Docket Item # 4
BAR CASE #2011-0363

BAR Meeting
January 18, 2012

ISSUE: Certificate of Appropriateness (storefront reconfiguration)
APPLICANT: East Banc, Inc. by Robert M. Gurney, FAIA
LOCATION: 326 King Street
ZONE: KR/King Street Retail

Figure 4: View of a similar retail building at 325 S Washington Street.

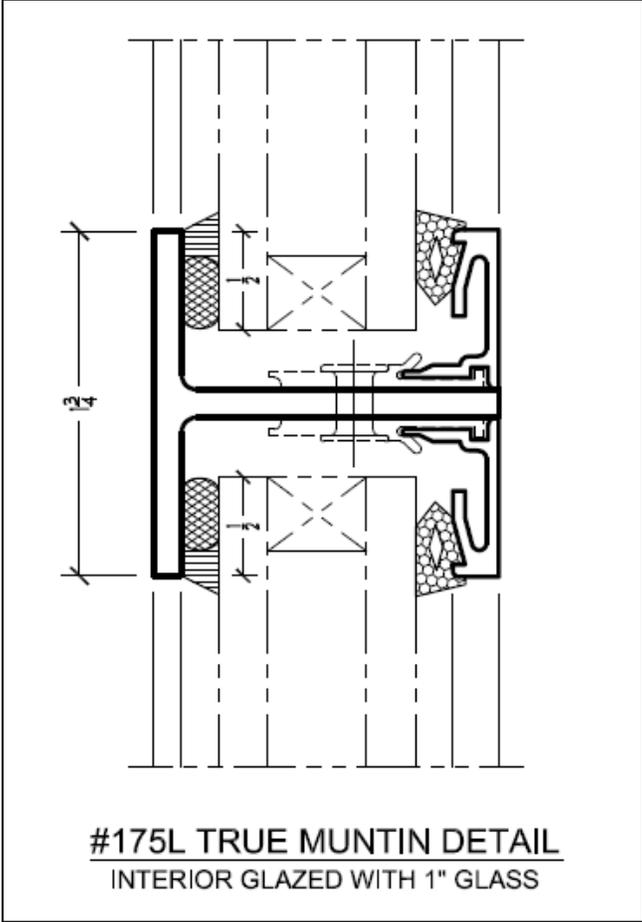
Commercial storefronts historically had large open windows that allow individuals to see into the space from the street or sidewalk. These large openings provide light into the store, display products for sale, and contribute to personnel safety. The structure that sat on this site before it was torn down to accommodate an urban renewal project had large open storefront windows with paneling beneath them and a recessed door opening (figure 3). In reflecting this historic feature, the applicant has chosen to open the first floor up through a more modern approach that suits the 1961 date of construction. An earlier design study showed one long continuous glass storefront which created the uncomfortable illusion that the masonry second floor of the building was floating. Staff feels the present proposal is innovative while also sensitive to the remaining portions of the structure. The new window openings are well proportioned and align with the smaller window openings on the second floor. They allow significantly improved visual access to retail displays on the building interior, yet remain in scale with the overall façade and retain the load bearing masonry building character. The custom designed metal sash window and door frames are high quality and contemporary without shouting above the traditional building form and materials. A similar modern interpretation of a Colonial Revival building with modern commercial store windows can be found at 325 S. Washington Street (figure 4).

Figure 6: Proposed exterior light fixture.

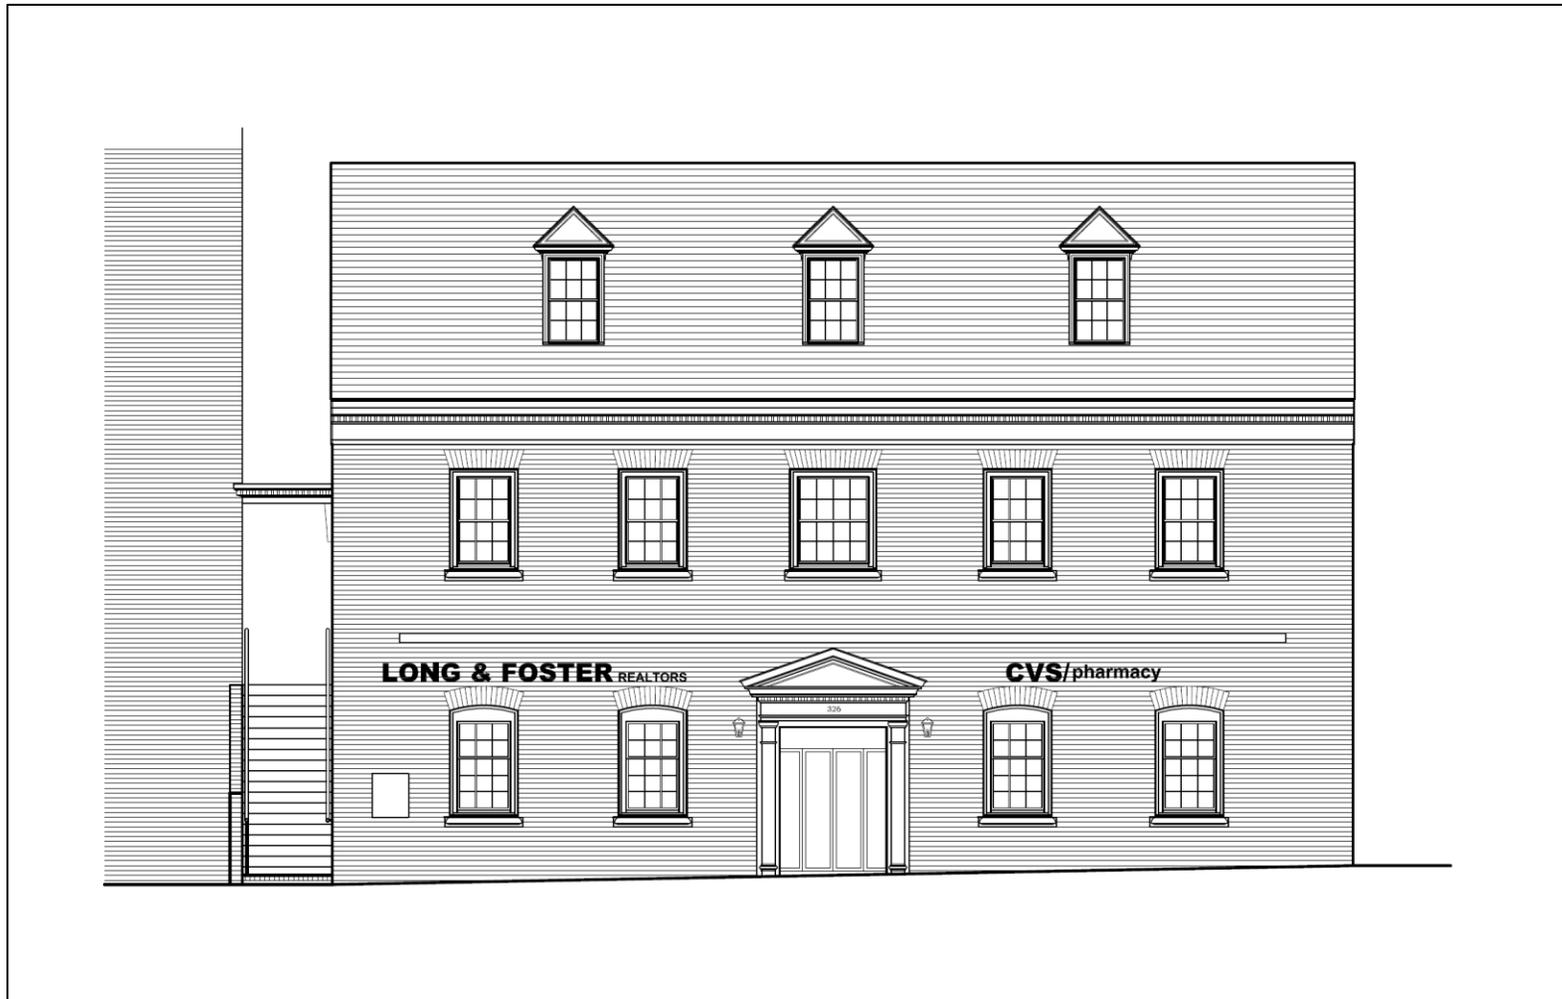
The applicant is proposing that new exterior light fixtures flank each side of the new openings, creating a repetitive rhythm down the front façade. These light fixtures are untreated copper and will achieve full patina over time. The fixtures will extend 17.5" from the wall and are 8.5" tall with a 100W incandescent bulb. Staff feels these high quality light fixtures conform to the *Design Guidelines*, and therefore, supports their installation.

Figure 9: Proposed elevation of King Street façade.

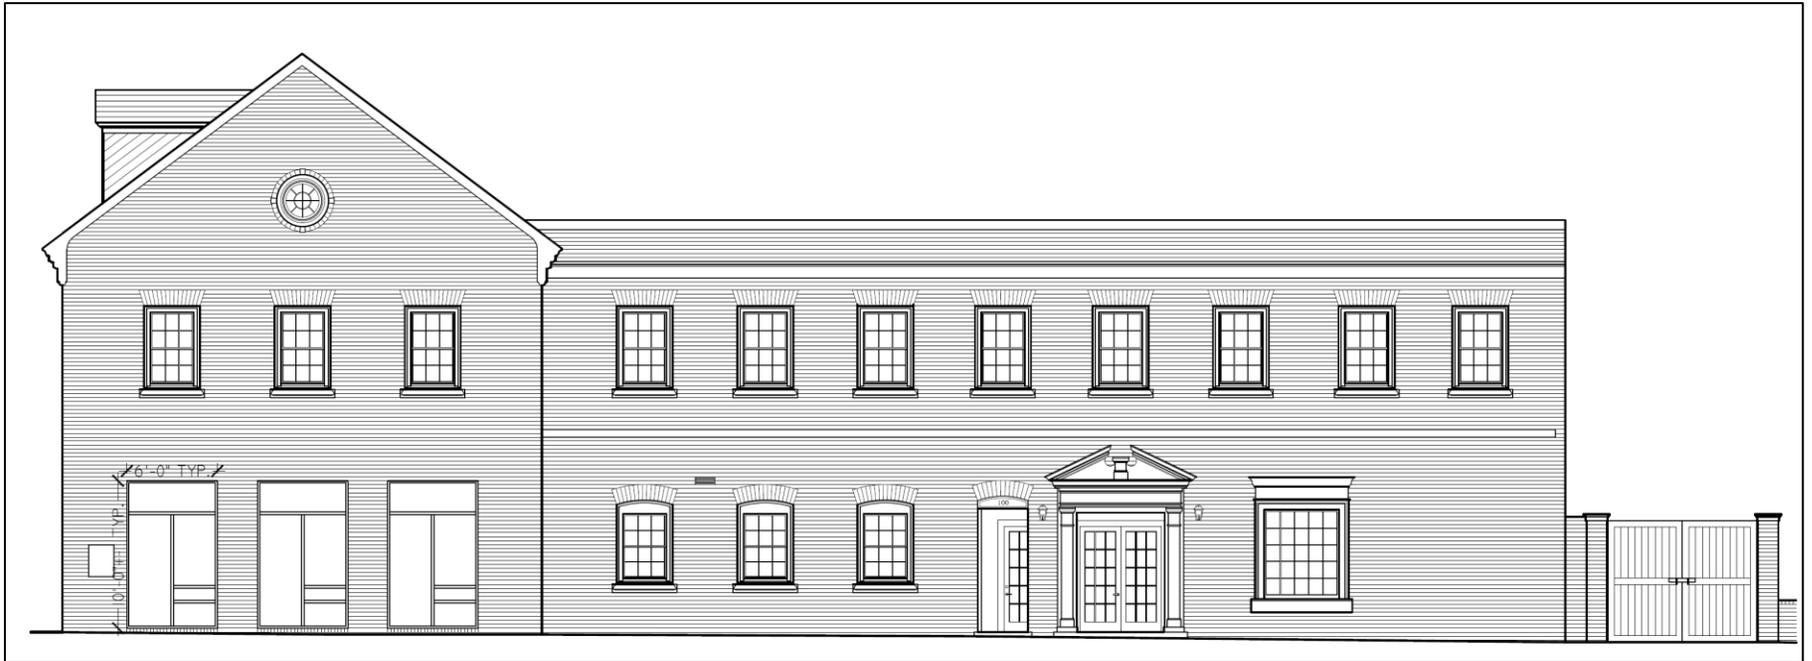
The Design Guidelines state that "buildings with multiple businesses and retail tenants should have a sign plan providing for coordinating graphics and placement." In the mock up, the applicant shows the two CVS and the two Long and Foster signs removed from the façade. However, they do not include a proposed coordinated sign plan for new signage. Staff supports the simple signage shown in the transom above the King Street entrance, as seen in Figure #9, but does not feel that the existing reverse channel individual letter illuminated signs are

appropriate for this structure, as they are too numerous and cumulatively out of scale, especially considering the proposed reconfiguration. Staff recommends approval of the reconfigured storefront with the condition that the overall signage for this building be restudied, including a stipulation that the second floor office tenant only have signage at their entrance which is located on the rear portion of the building on S Royal Street.

1. That the existing CVS signage and the second floor office signage be removed from the north and west elevations and that a coordinated sign plan for this building be submitted to the Board before any new signs are approved for the ground floor tenant;
2. That the applicant clean and repaint the concrete egress stairs on the east side of the King Street façade.
